Re: Objection against planning application: 2016/6194/P

Site Address: 49-51 Farringdon Road London

Application Description: *Internal and external alterations, extensions and reconfiguration of building to provide a replacement roof extension at fifth floor level; a first floor rear extension; internal reconfiguration and extension of retail (A1), healthcare (D1) and office (B1a) uses with an overall uplift of 115sq.m (GIA); restoration of facade and upgrading of shopfront; alterations to rear elevation and associated additions/alterations.*

Figure 2: clear glazing provides daylight, sunlight and outlook to the reception & waiting area

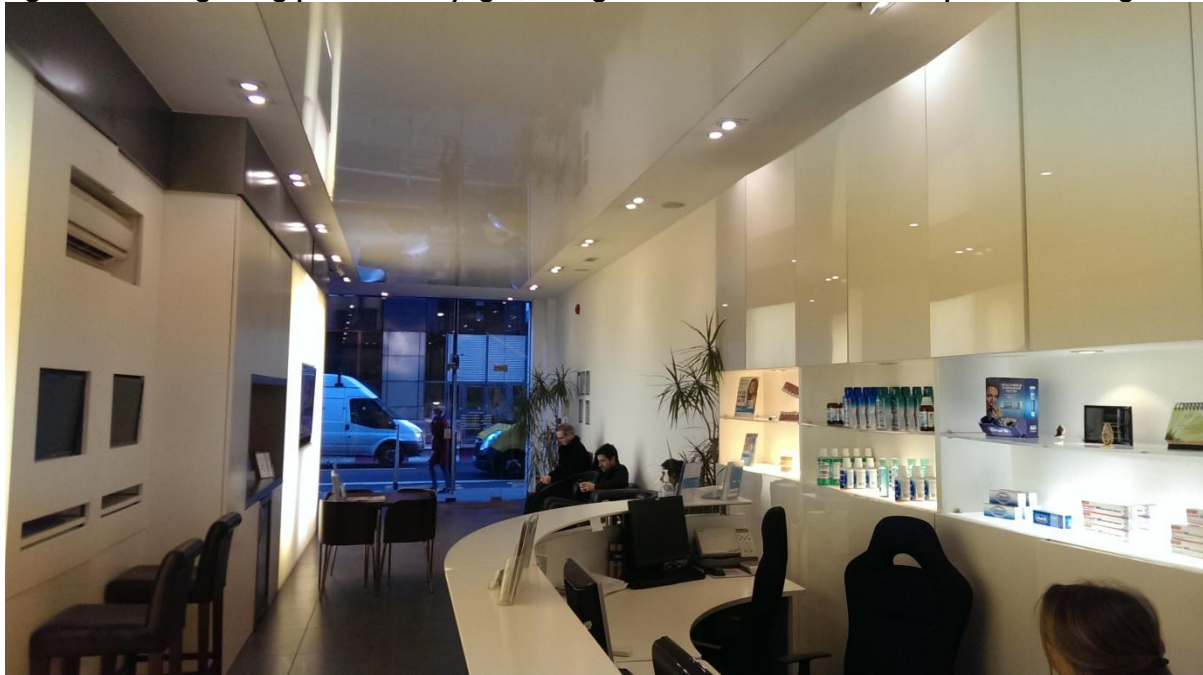
Patient waiting rooms require natural light to create a sense of ease and calm and the proposed relocation of the waiting room to the lower ground floor would result in an enclosed and uncomfortable environment for patients, particularly for first time or anxious visitors as well as young children. The existing skylights located within 3 of the 5 surgery rooms provides patients with a pleasant view out when inclined in the chair and offers a distraction

Figure 9(a): privacy glass enclosure transmits natural light from corridor skylights

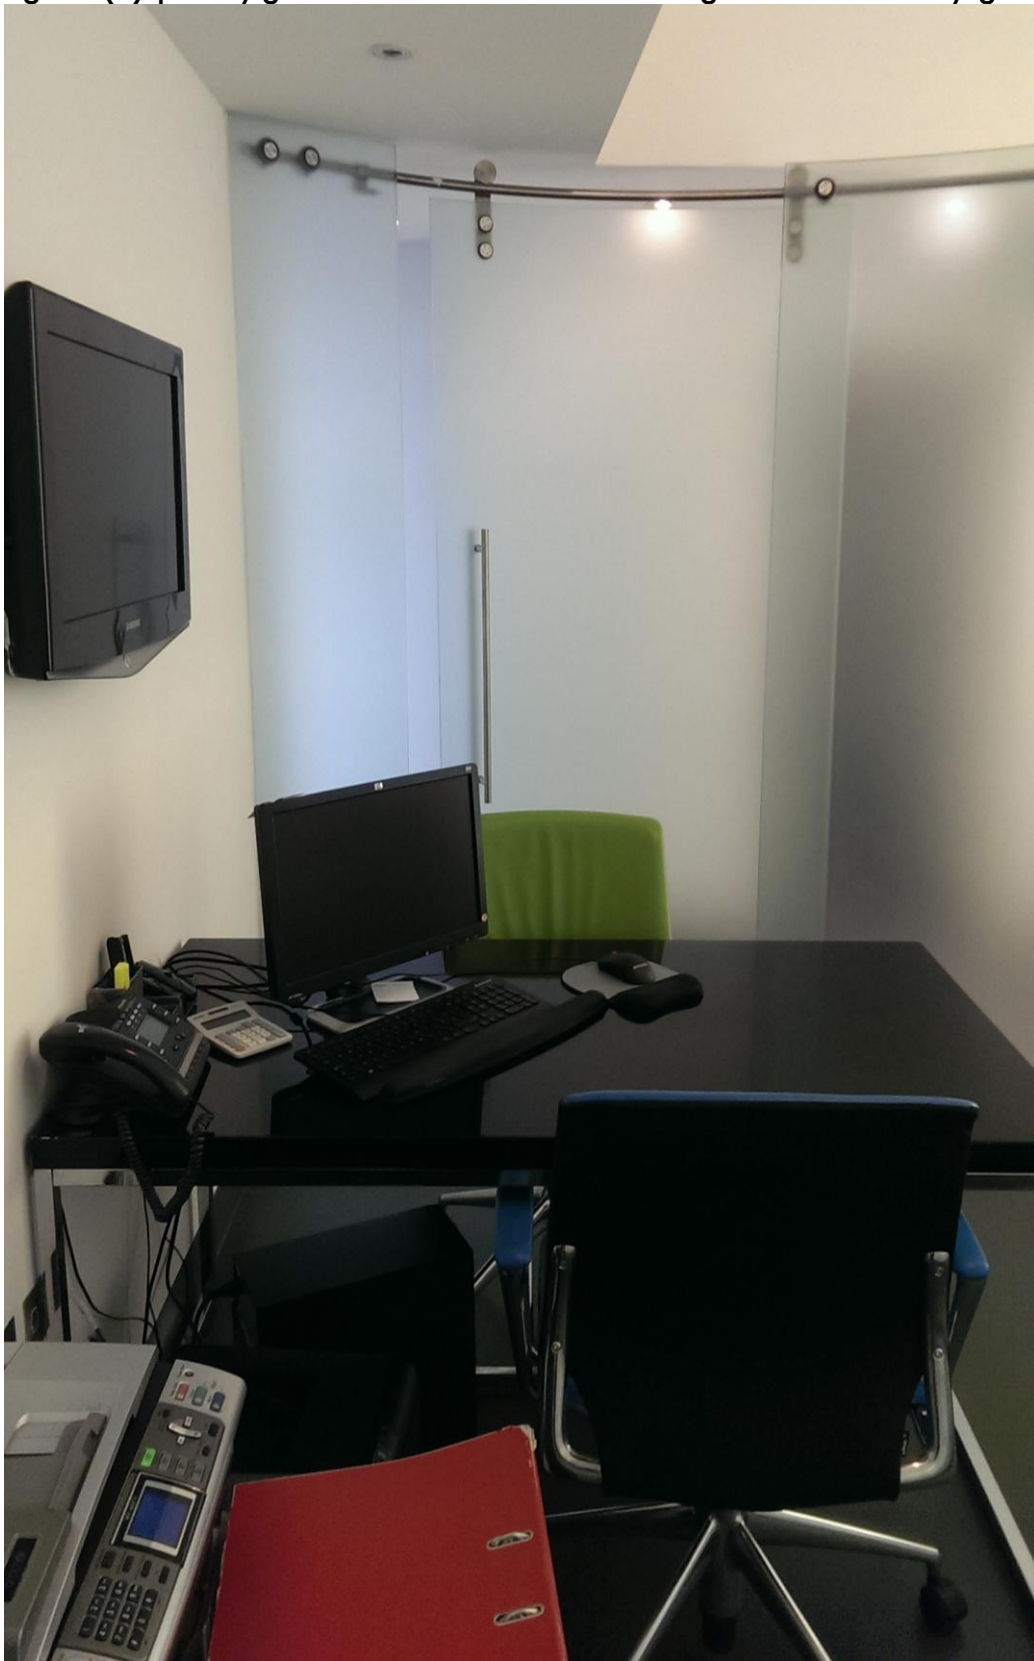
while undergoing long treatment sessions. Furthermore all surgeries, particularly those without natural light sources, receive natural daylight through internal glazed partitions from the skylights within the corridors (see figure 3 and 4). The skylights within the surgeries provide an important connection to the open environment outside and without this would result in patients and staff feeling confined and claustrophobic. Daylight, sunlight and views from within the surgeries provides respite for staff and allows views of weather changes which helps establish a time of day during long shifts. The skylights within the corridor spaces also provide an important visual connection to the outside and allow procedures that require natural light to be carried out.
